Lincoln Home National Historic Site

Accessibility Assessment

FINAL REPORT

Findings and Recommendations

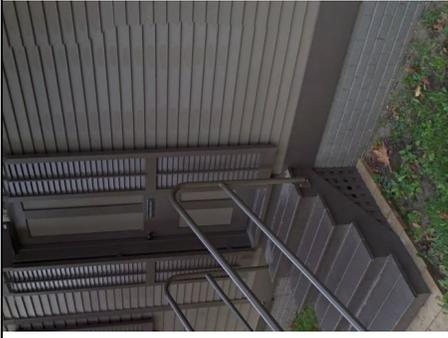
<p>Location: Accessible ramp Corrective Action: Replace handrail</p>			
<p><u>Deficiency</u> The handrails on the ramp do not extend far enough.</p>	<p><u>Solution</u> Replace the handrails on the ramp so that they extend 12" minimum beyond the top and bottom of ramp run.</p>	<p><u>Criticality</u> Serious</p> <p><u>Timeframe</u> Short-term</p>	 <p>LIHO_Arnold House_LMK_002</p>
<p>Reference Standards and Guidelines: ABAAS 505.10.1</p>			
<p>Location: Accessible entrance stairs Corrective Action: Replace handrails</p>			
<p><u>Deficiency</u> The handrails for the stairs do not extend far enough.</p>	<p><u>Solution</u> Replace the handrails for the stairs so that they extend 12" minimum at the top and extend the length of one tread beyond the last riser nosing.</p>	<p><u>Criticality</u> Serious</p> <p><u>Timeframe</u> Short-term</p>	 <p>LIHO_Arnold House_LMK_006</p>
<p>Reference Standards and Guidelines: ABAAS 505.10.2, 505.10.3</p>

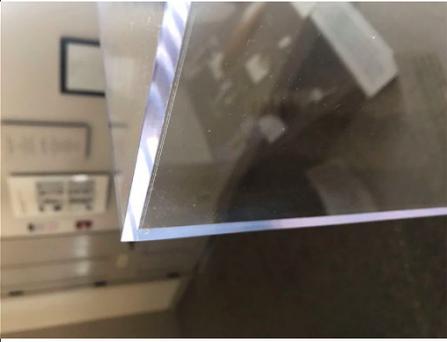
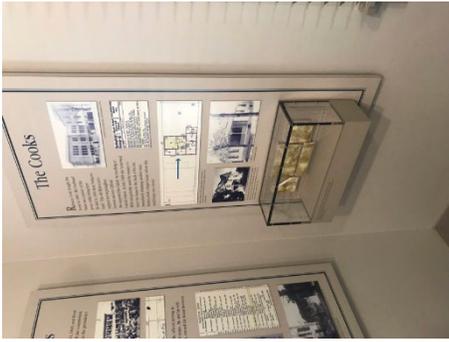
<p>Location: Main entrance stairs Corrective Action: Rebuild stairs</p>			
<p><u>Deficiency</u> Current stairs do not have curved or beveled nosings.</p>	<p><u>Solution</u> Rebuild the stairs so that the nosings are curved or beveled and project no more than 1.5" over the tread below.</p>	<p><u>Criticality</u> Minor</p> <p><u>Timeframe</u> Short-term</p>	 <p>LIHO_Arnold House_LMK_002</p>
<p>Reference Standards and Guidelines: ABBAS 504.5</p>			
<p>Location: Arnold House main entrance Corrective Action: Replace doorknobs</p>			
<p><u>Deficiency</u> The doorknobs do not meet accessibility standards as they require tight grasping and twisting of the wrist.</p>	<p><u>Solution</u> Replace the doorknobs with lever-shaped handles that do not require tight grasping, pinching, or twisting of the wrist.</p>	<p><u>Criticality</u> Minor</p> <p><u>Timeframe</u> Short-term</p>	 <p>LIHO_Arnold House_LMK_023</p>

Location: Beedle House
Corrective Action: Add handrails to stairs

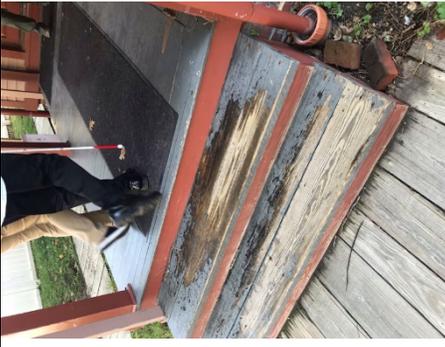
The stairs leading to the house do not all have handrails on both sides.

Add handrails to both sides of all stairs. Ensure handrails return to a wall, guard, or the landing surface. Handrails should extend 12" at the top beginning directly above the first riser nosing and should extend for a distance equal to at least one tread depth at the bottom.

Location: "A Lot of Activism in the Neighborhood" wayside

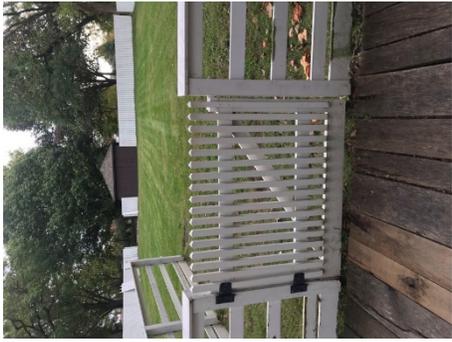
<p><u>Deficiency</u> The fence in front of the wayside is 42.75" high and blocks the view for individuals with short stature or those using a wheelchair.</p>	<p><u>Solution</u> Relocate the wayside to the section of the fence that has a gated entrance. Remove the gate entirely and place the wayside in the threshold to block visitors from entering the yard.</p>	<p><u>Criticality</u> Serious</p> <p><u>Timeframe</u> Short-term</p>	 <p>LIHO_Circulation Path_LMK_240</p>  <p>LIHO_Circulation Path_LMK_243</p>
---	--	--	--

Corrective Action: Relocate wayside
